December 1999

MAINTENANCE BULLETIN

Alfa Company

Figure 1

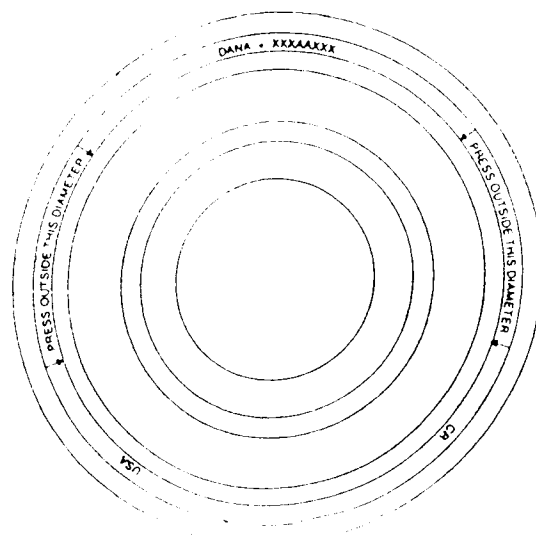
Installation procedures for the new unitized pinion seal **P/N HH105** (Navistar **P/N 2503294C1**). Introduced Jan 4, 1999 in N model single rear axles and rear input of N400 tandem axles.

Provide the customer with installation instructions for the unitized seal that replaces the 401HH102 and GGAHH103 seals for service in the following models.

4. Remove slinger from end yoke and clean yoke surface that will be in contact with Seal. Use Emery cloth to remove any build-up present in the area shown. (See Figure 1)

5. Using OTC seal installation tool (DST 1021) with handle (DST 1000-1), install unitized seal until fully seated into bearing retainer. (See Figure 2 for installation tool location on seal.)

Illustration 1. Typical Signal Lighting Group.

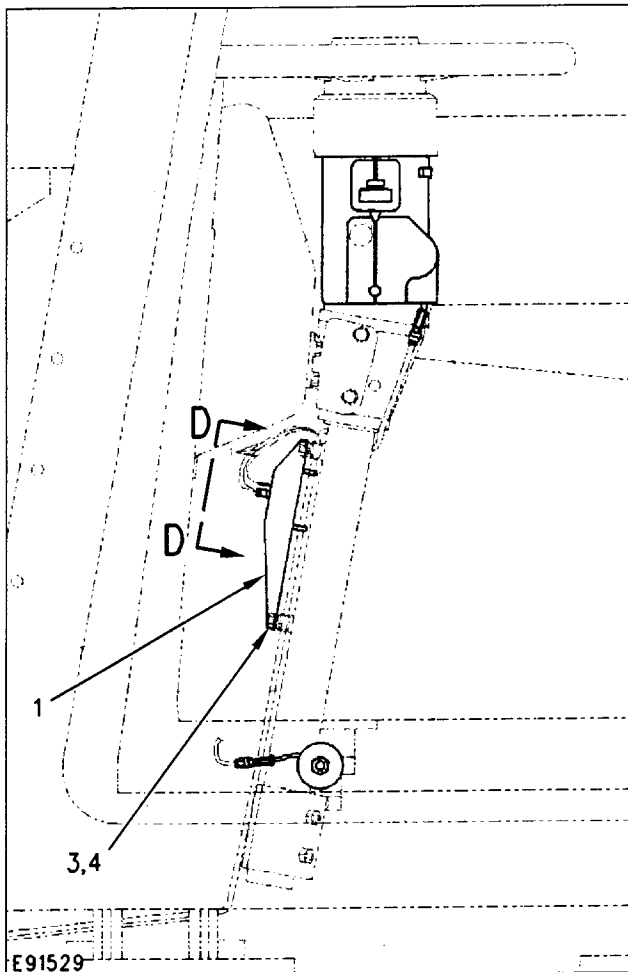
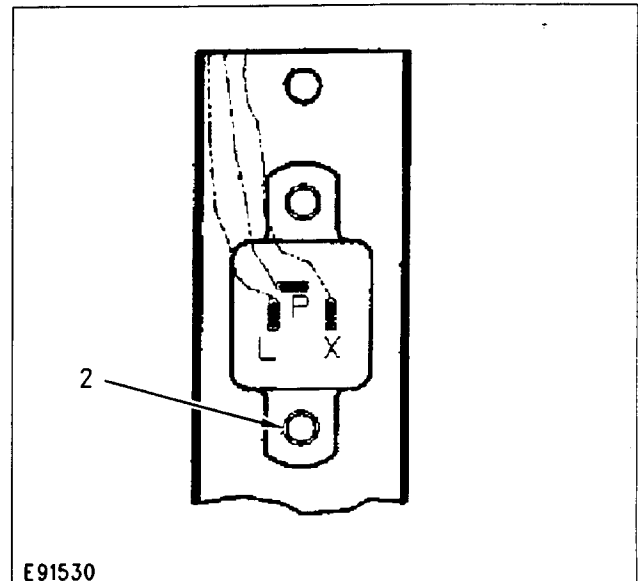
Description Of Change: The flasher control has been relocated and mounted on a new bracket to protect it from accidental foot contact.

Adaptable To: The change to the 2T-3374 Signal Lighting Group adds a new 8I-2083 Bracket and two 9S-2437 Screws and is effective with 613C-II (8LJ1972) and 615C-II (9XG1266) Wheel Tractors. The change to the 8I-2074 Signal Lighting Group adds a new 8I-2083 Bracket and two 9S-2437 Screws and is effective with 611 (6SZ191) Wheel Tractors. The changes are adaptable to earlier machines by the following procedure.

1. Remove flasher control from the underside of the dash.
2. Mount flasher control to the new 8I-2083 Bracket (item 1) using two 9S-2437 Self-Tapping Screws (item 2).
3. Mount the new 8I-2083 Bracket (item 1) to the two existing bosses located on the back side of the steering column using the two existing 8T-9371 Bolts (item 3) and the two existing 8T-4896 Washers (item 4).

E96128

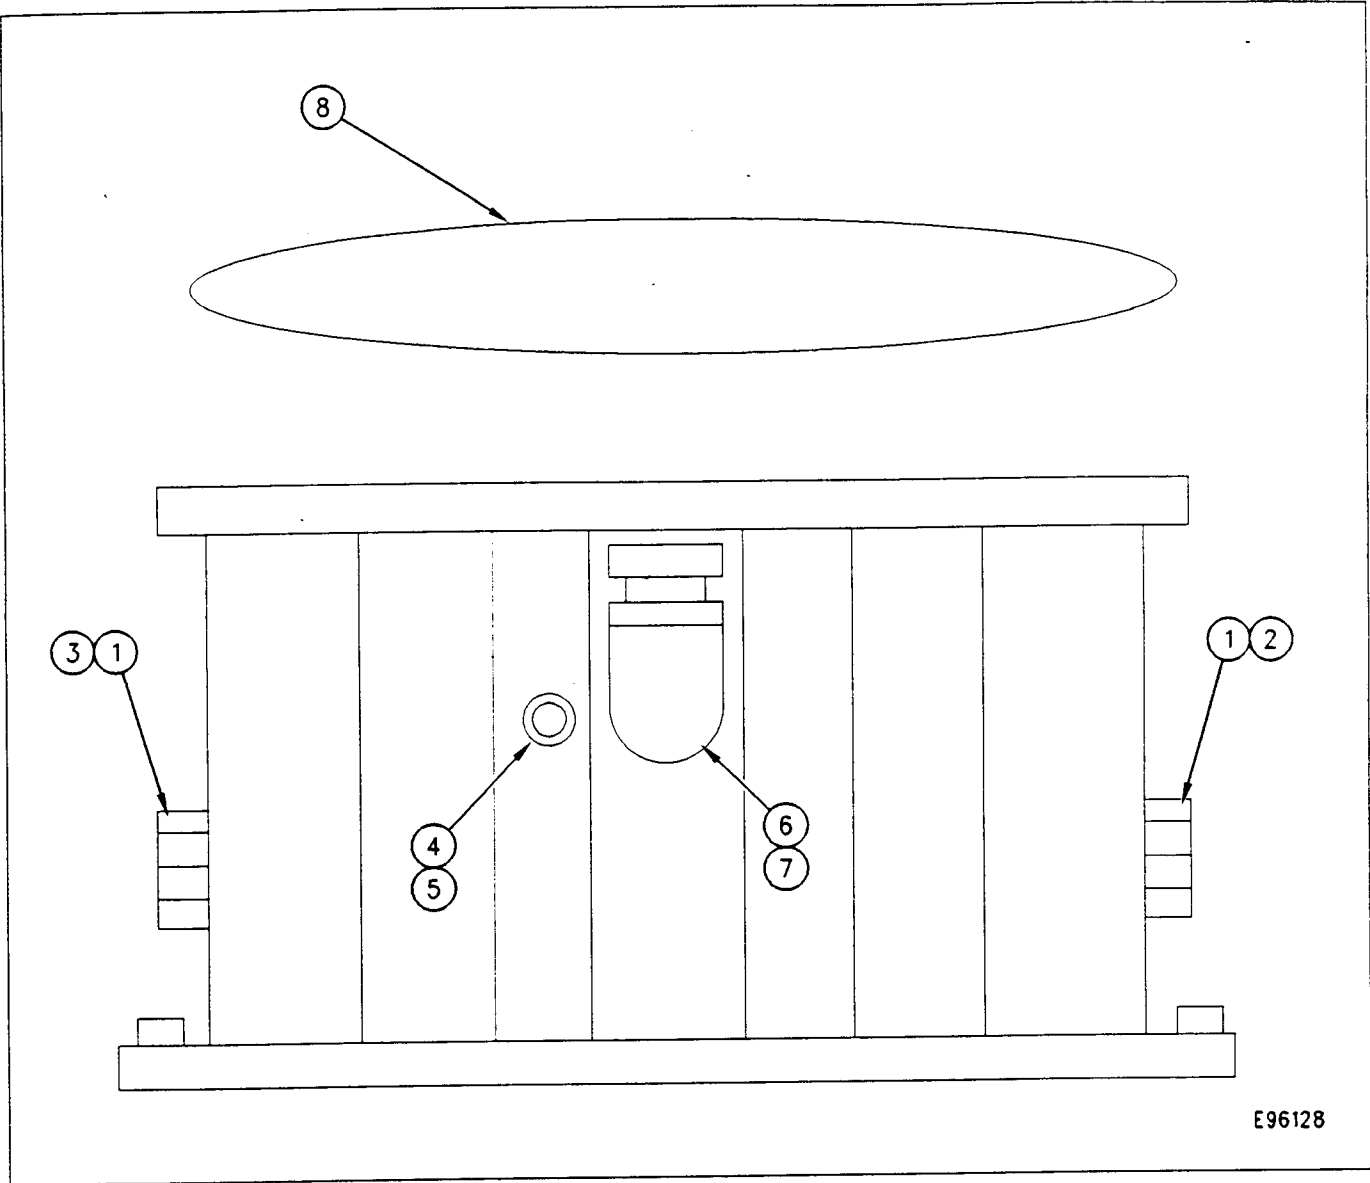
Description Of Change: The former 122-7119 Brakes have been canceled and replaced by the new 171-2134 Brakes. The new brakes are a direct replacement for the former 122-7119 Brakes. Changes to the new brake group include the following:

When installing the new brake, new fittings and seals will need to be installed. See the following chart and illustration for required part numbers and their locations.

(1) 8L-2786 Seal, (2) 171-2972 Indicator, (3) 9S-4185 Plug, (4) 5P-7812 Seal, (5) 9S-8001 Plug, (6) 003-2143 Elbow, (7) 171-5286 Breather, (8) 117-8801 Seal, (to be installed between the propel motor and the brake).

Bolt identification for "20 Bolt" flywheel housings.

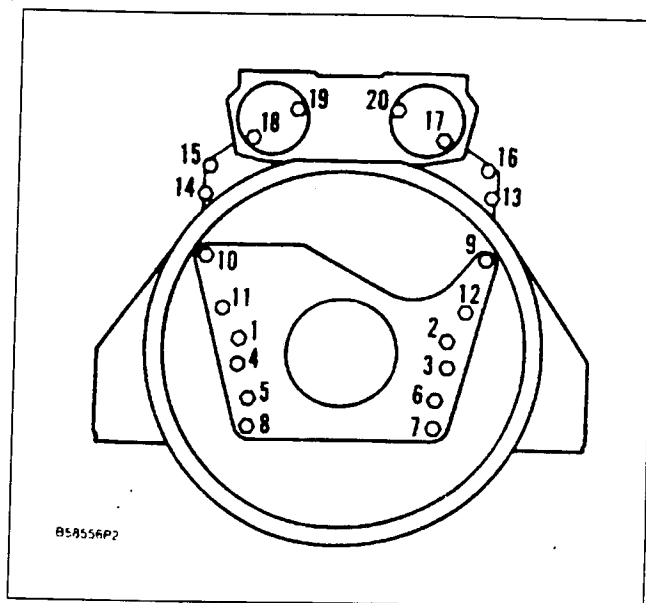
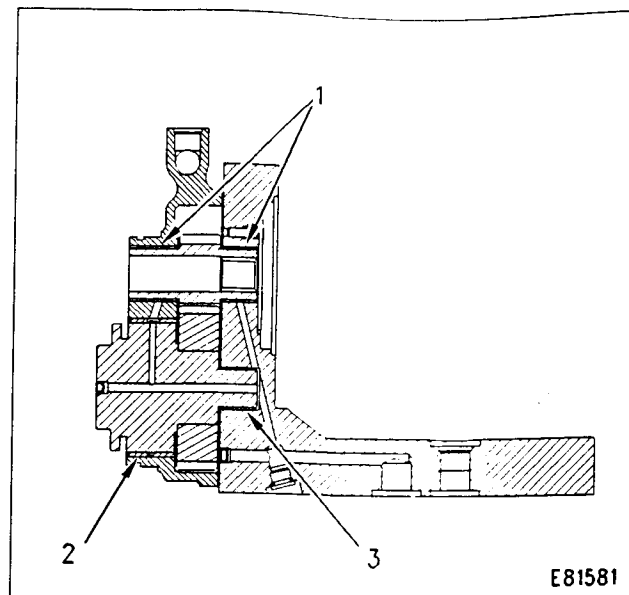
Description Of Change: The flywheel housing to cylinder block joint uses a gasket to improve the integrity of the joint. The new gaskets are a steel core composite design with beading between the upper bolt holes to increase gasket loading in the tongue area of the housing.

Using the new 109-4318 or 113-1474 Flywheel Housing Gaskets on a flywheel housing originally designed for use with sealant may require elongation of the bolt holes in the pan, oil pan gasket, and stiffener plate (if equipped). The gasket is approximately 0.76 mm (.030 in) thick. Before engine operation, check the clearance between the flywheel housing and rear gear train and flywheel. Push the crankshaft towards the front of the engine when checking the flywheel to flywheel housing clearance. Flywheel housings designed for gaskets have a 16.76 mm (.660 in) dimension from the flywheel housing to the centerline of the oil pan mounting bolts. Flywheel housings designed for sealant have a 17.46 mm (.688 in) dimension from the flywheel housing mounting face to the centerline of the oil pan mounting bolts. These housings are usually marked with the note "CAUTION: USE ONLY LIQUID GASKET ON BLOCK JOINT" on the inside of the housing.

1. Tighten bolts 1 through 20 in numerical sequence to a torque of $40 \pm 10 \text{ N}\cdot\text{m}$ ($30 \pm 7 \text{ lb ft}$).
2. Tighten bolts 1 through 8 in numerical sequence to a torque of $135 \pm 20 \text{ N}\cdot\text{m}$ ($100 \pm 15 \text{ lb ft}$).
3. Tighten bolts 9 through 20 in numerical sequence to a torque of $55 \pm 10 \text{ N}\cdot\text{m}$ ($40 \pm 7 \text{ lb ft}$).

New High Pressure Oil Hose Assembly Now Used (01-25-99)

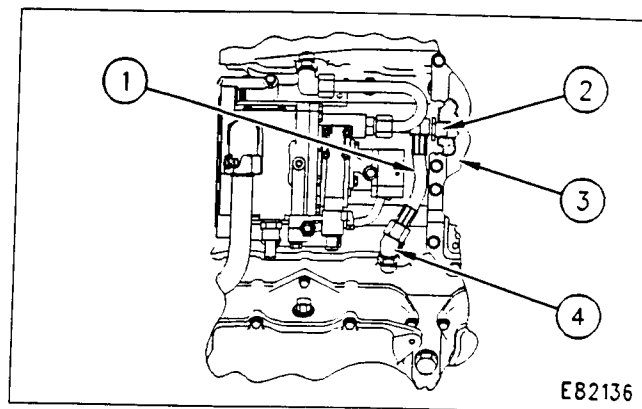
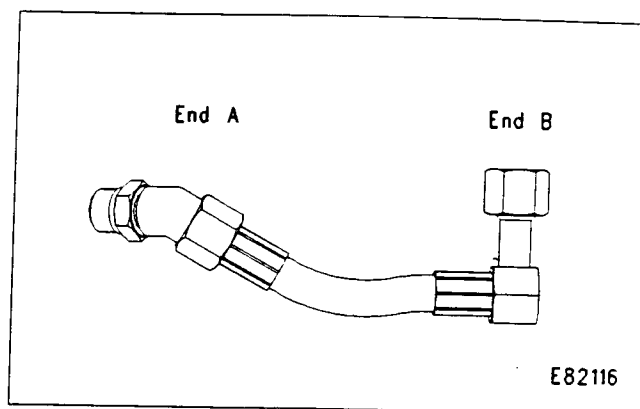
Description Of Change: A new more robust braided stainless steel hose assembly is now being used in the lines group for the unit injector hydraulic pump used in the 3408E and 3412E Engines that power the above machines. This new hose assembly allows for added flexibility and thermal expansion, which will extend its life and improve reliability.

1. Remove the old hose assembly 107-7942 with all fittings attached.
2. Remove elbow (4) that feeds the left high pressure manifold from the old hose assembly. This piece will be reused in the installation of the new hose assembly.

2.5. Remove 7W-6492 Plug from the aftercooler housing. Install new 8T-6762 Square Socket Plug (2) in aftercooler housing (3).

3. Install elbow (4) to the left high pressure manifold and hand tighten.
4. Hand tighten the nut on end A of 162-2501 Hose Assembly (1) to elbow (4).
5. Install hose end B to the pump fitting and tighten the nut to a torque of $125 \pm 15 \text{ N}\cdot\text{m}$ ($92 \pm 11 \text{ lb ft}$).
6. Hold end A elbow and tighten the jam nut to a torque of $143 \pm 15 \text{ N}\cdot\text{m}$ ($105 \pm 11 \text{ lb ft}$).
7. Tighten hose end A nut to a torque of $125 \pm 15 \text{ N}\cdot\text{m}$ ($92 \pm 11 \text{ lb ft}$).
